ISO/
IEC/IEEE
8802-3

AMENDMENT 2
2021-12

**AMENDMENT 2: Physical layer and
management parameters for power over
Ethernet over 4 pairs**

Reference number
ISO/IEC/IEEE 8802-3:2021/Amd.2:2021(E)

Figure 30-4—Repeater entity relationship diagram

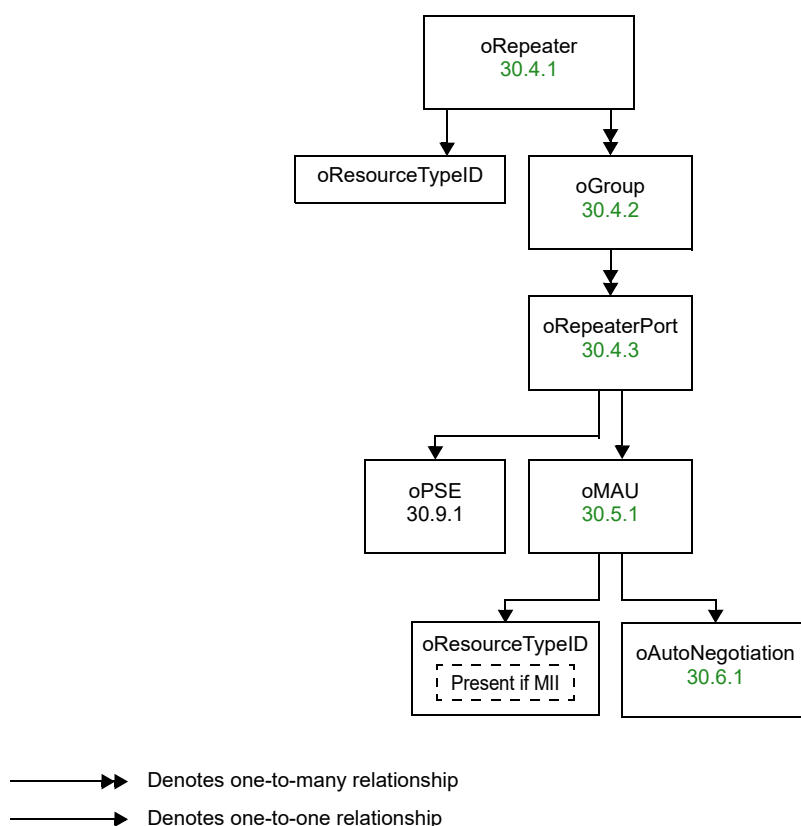
Replace Figure 30-4 as follows (oPD object deleted):
